## **ADDENDUM NUMBER TWO (2)**

**Issuance Date:** December 5, 2025

**Issued by:** Mike Nichols - Ashe Broussard Weinzettle Architects LLP

**Project Name:** Downtown Health Services Center  
Louisiana State University Alexandria  
Alexandria, Louisiana  
**Project Number:** 19-602-23-01, F.19002498, Site Code: 6-40-023  
**Architect Project Number:** ABW: 2023.28 Tipton: 1531.00-23

A510

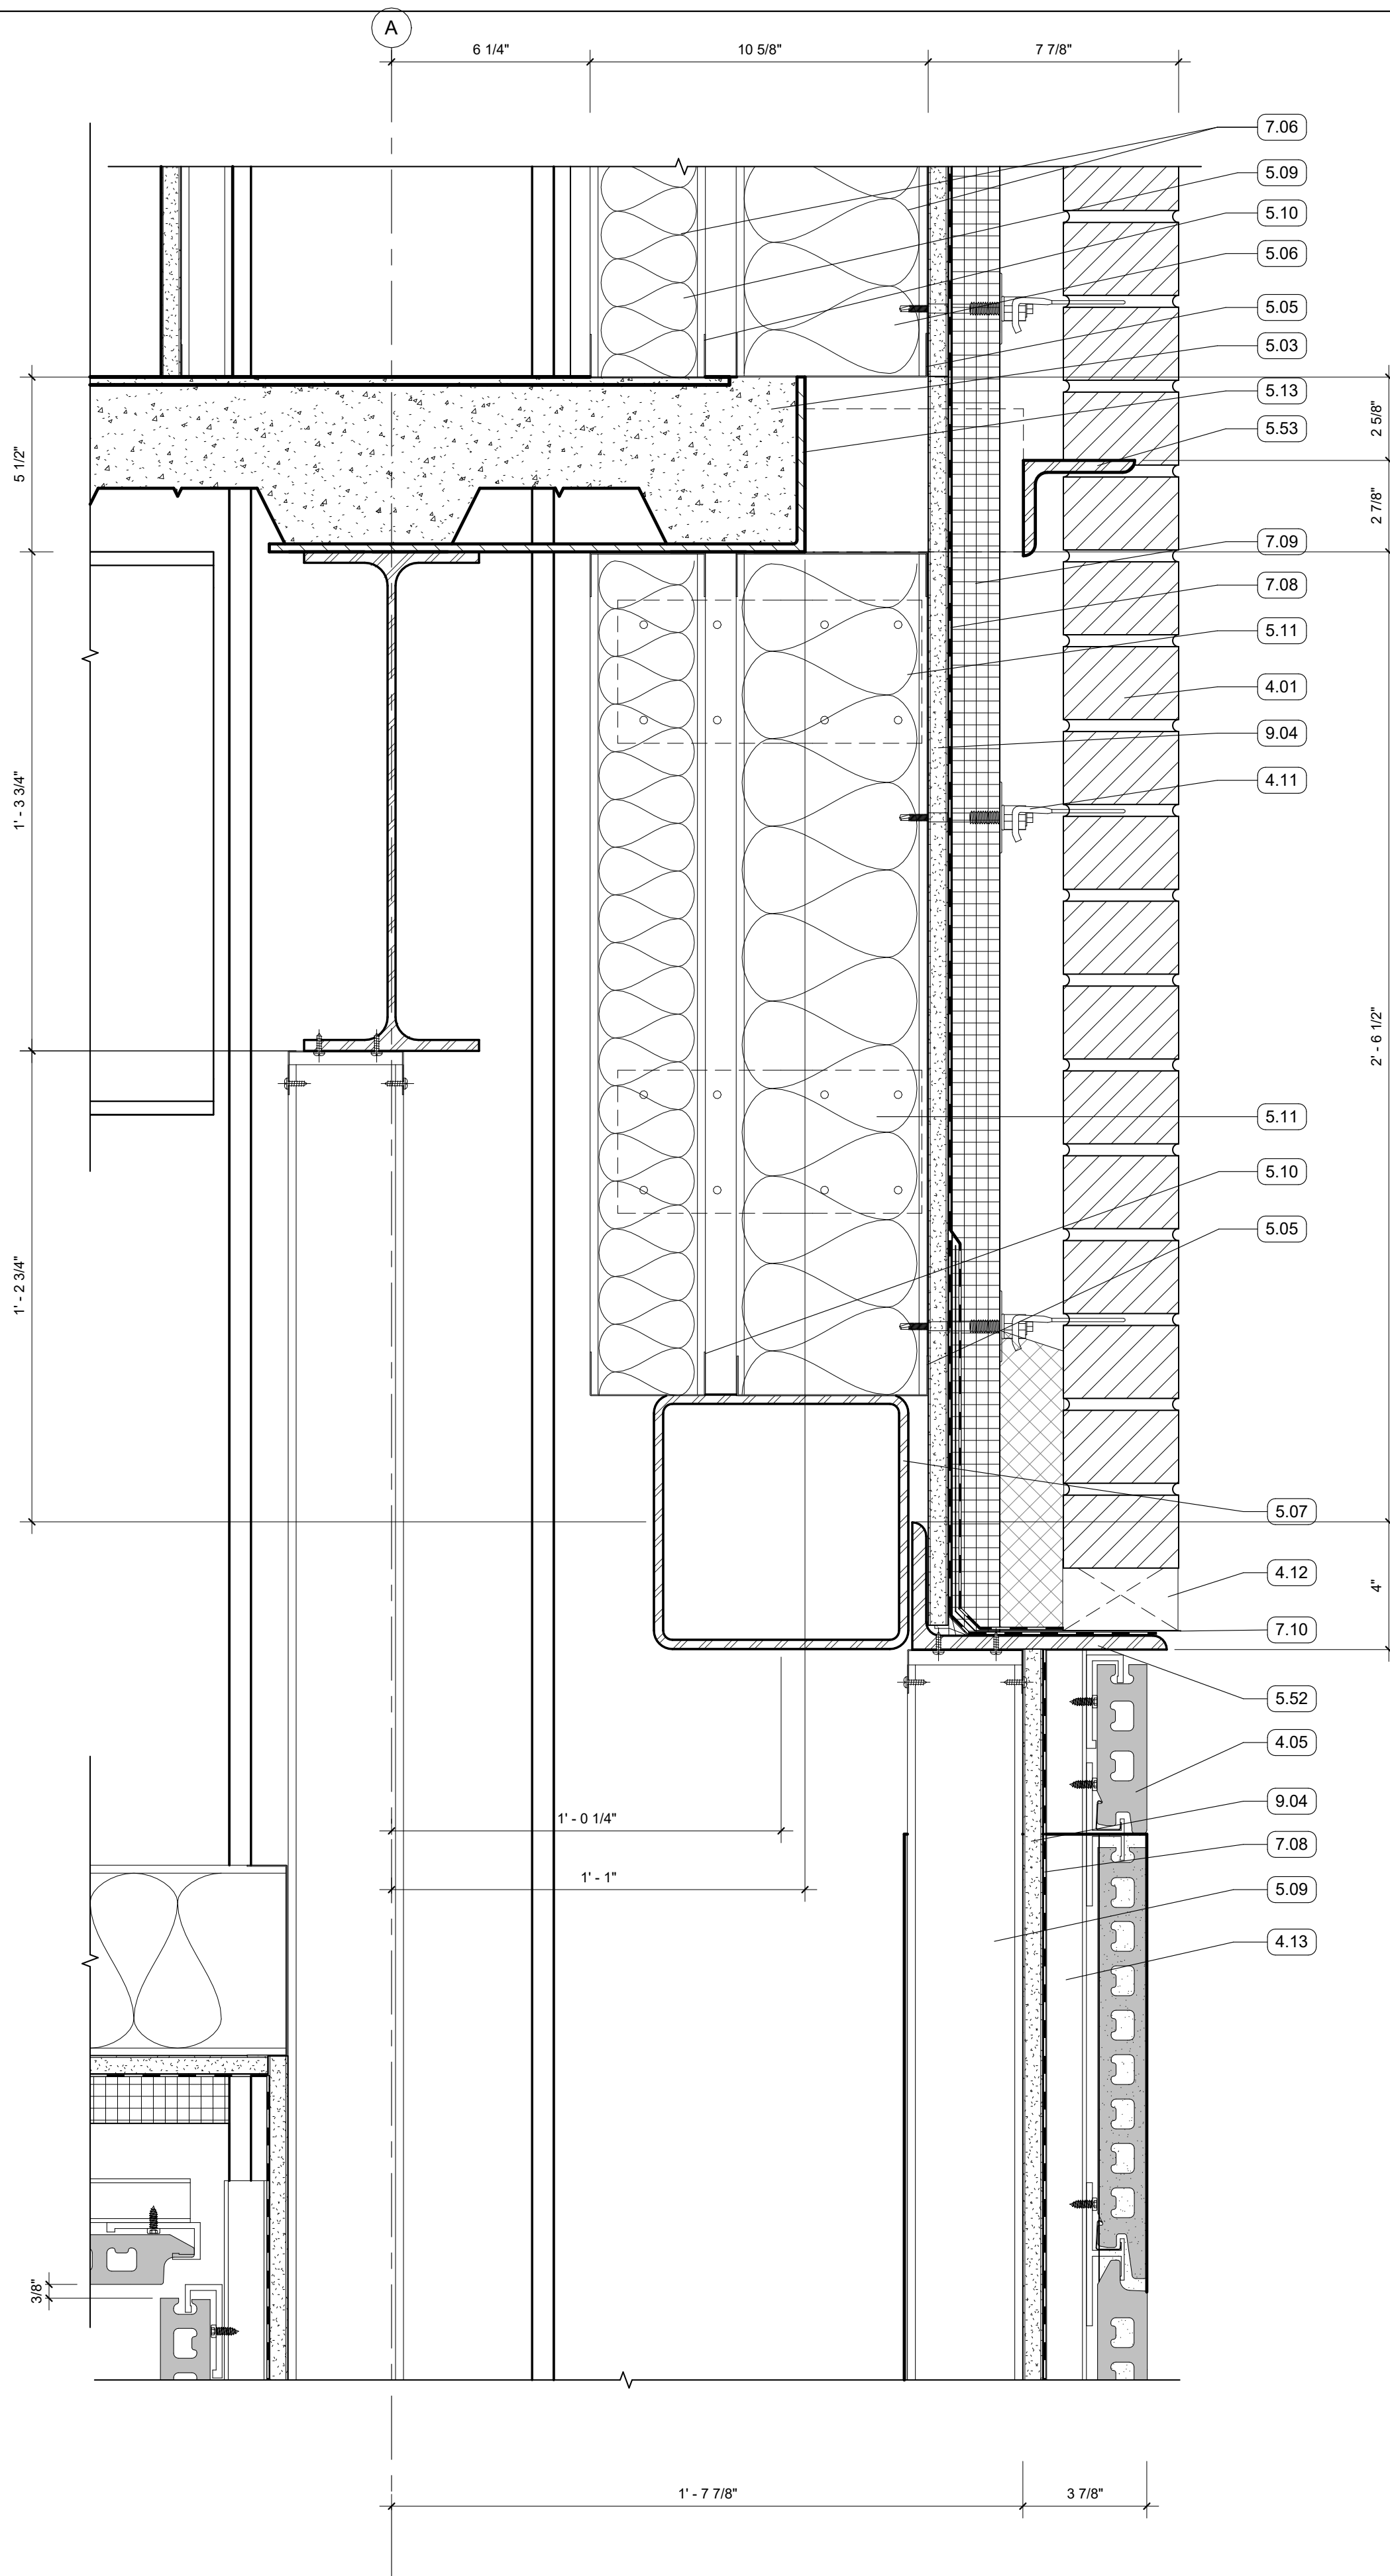
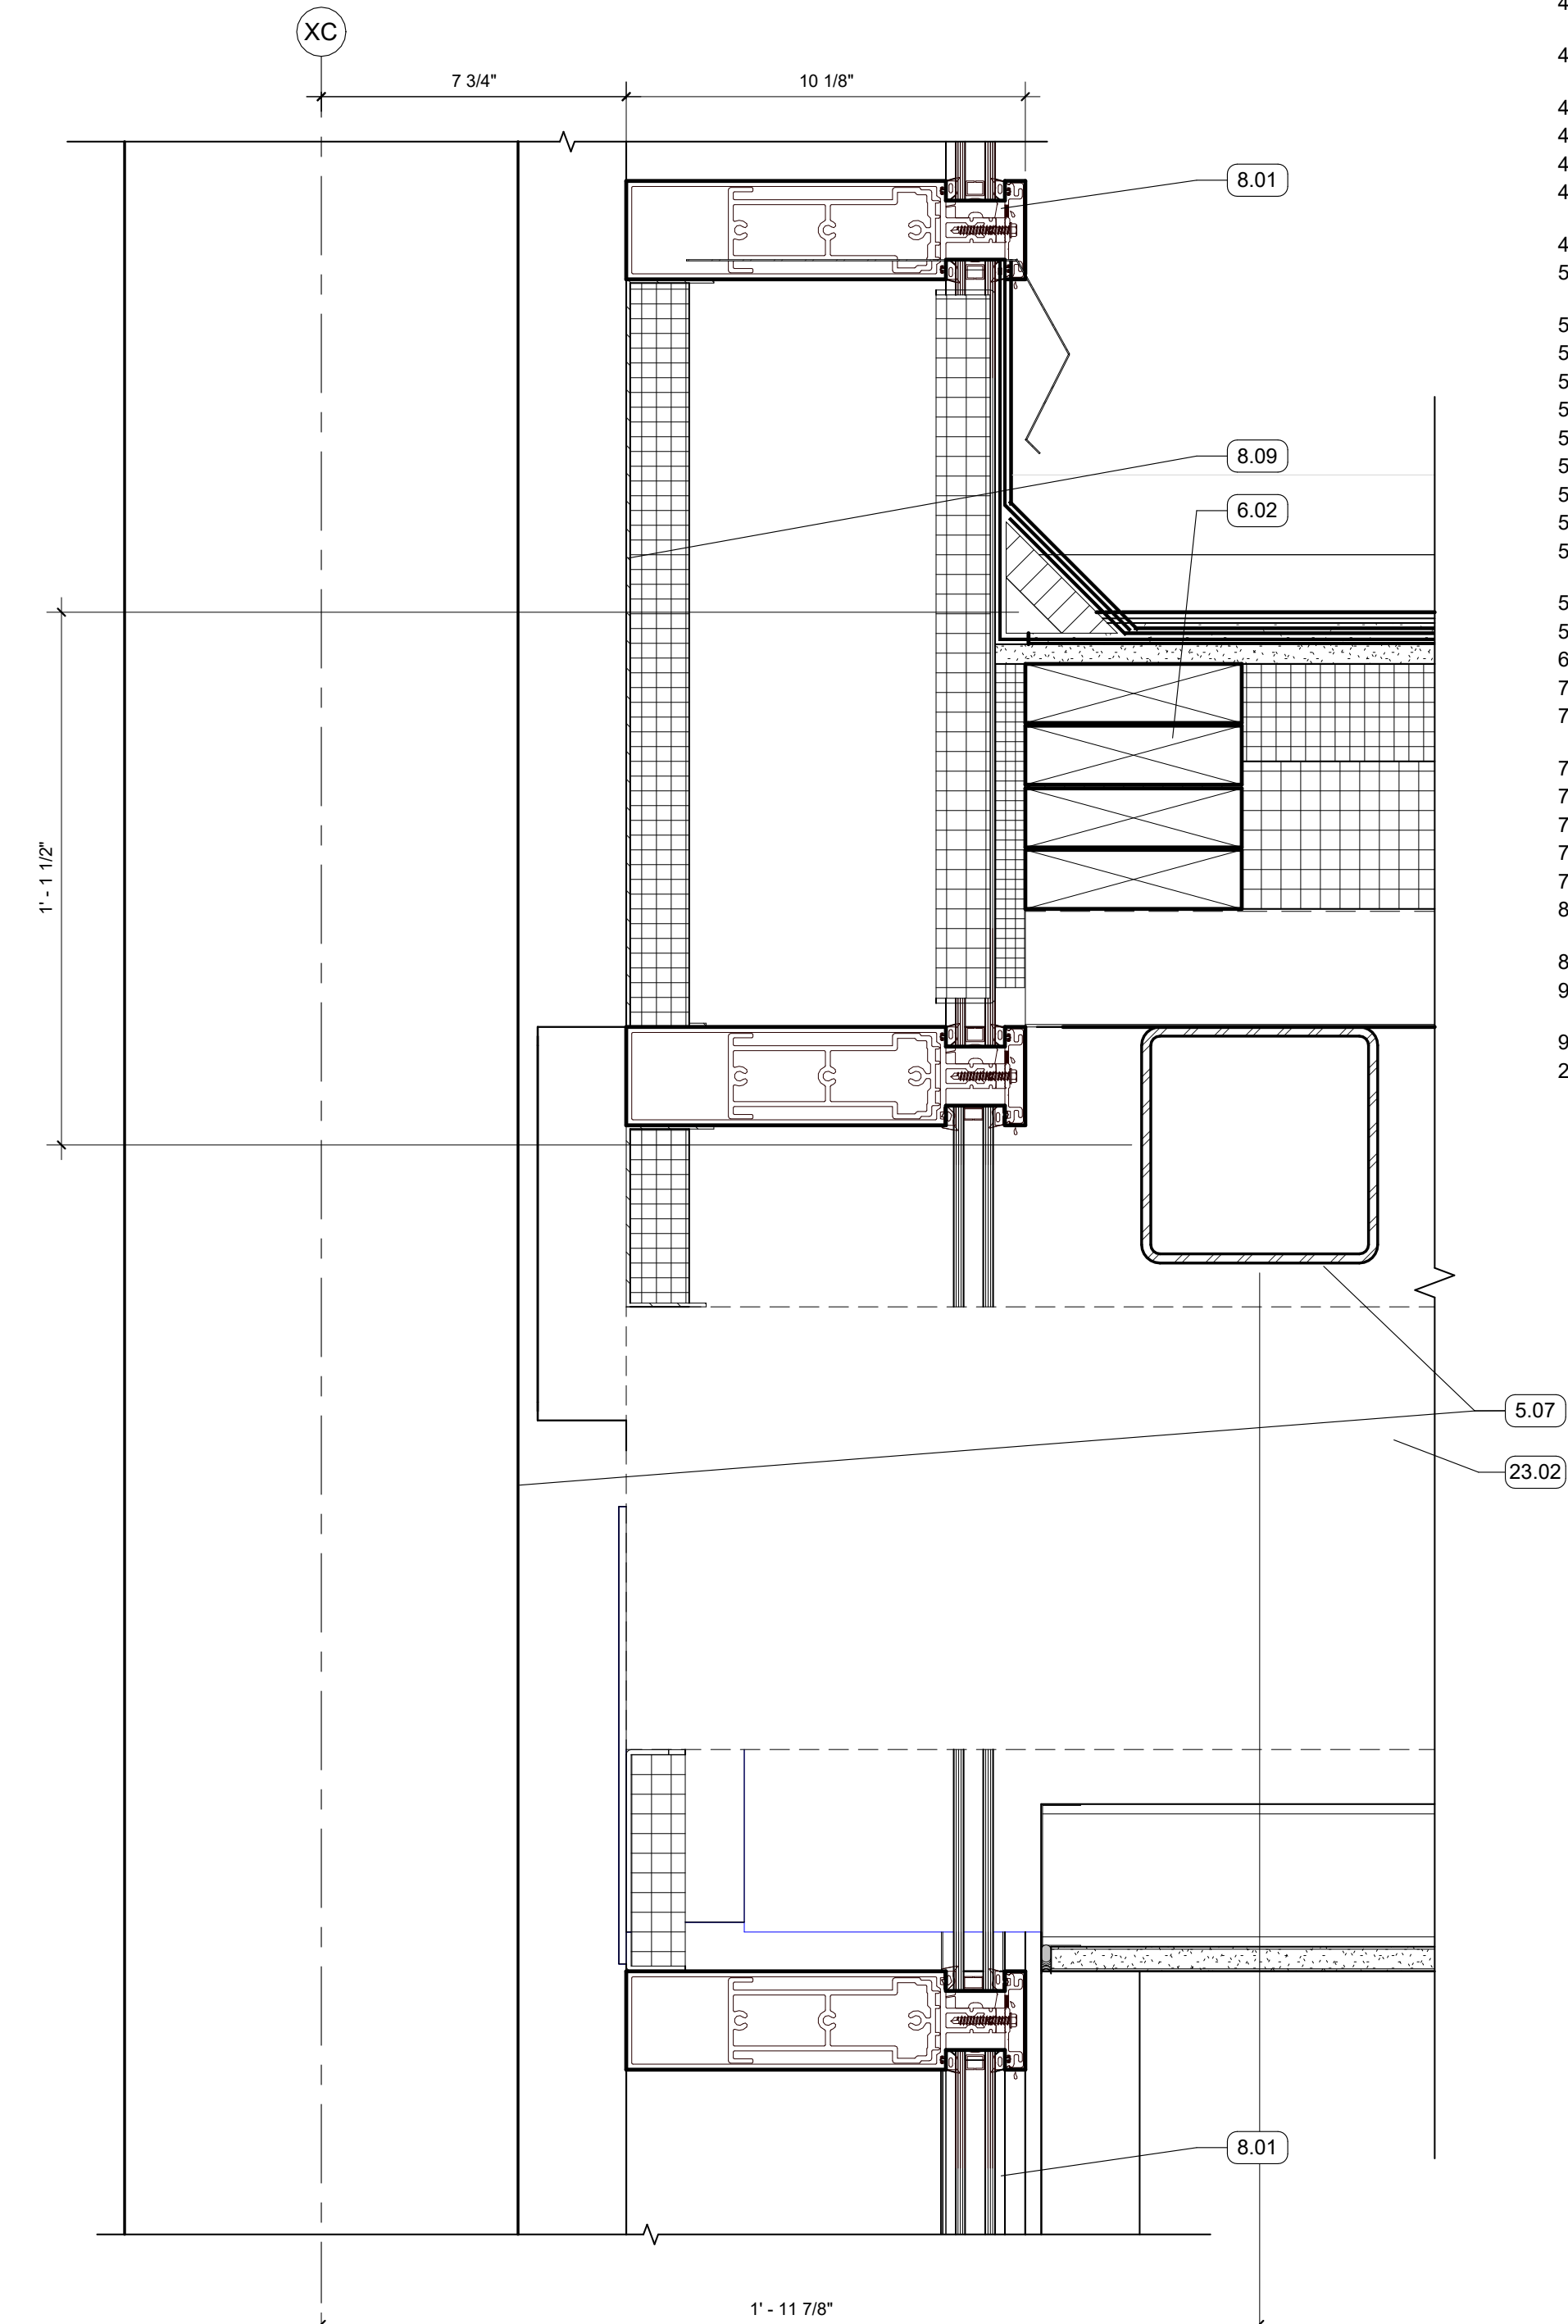
1. Foam-in-Place Insulation RE: 07 21 19, 1.01.A.3
  1. Can spray foam locations be shown on the wall Section drawings?
  2. What thickness or R-value is needed at application locations?
  3. Will the spray foam require an intumescent coating?

**RESPONSE:** Foam-in-place insulation indicated on exterior section details, Drawing Series A510. Detail 3/A511 provides a typical installation intent to close non-insulated parapet knee walls from interior insulated walls.
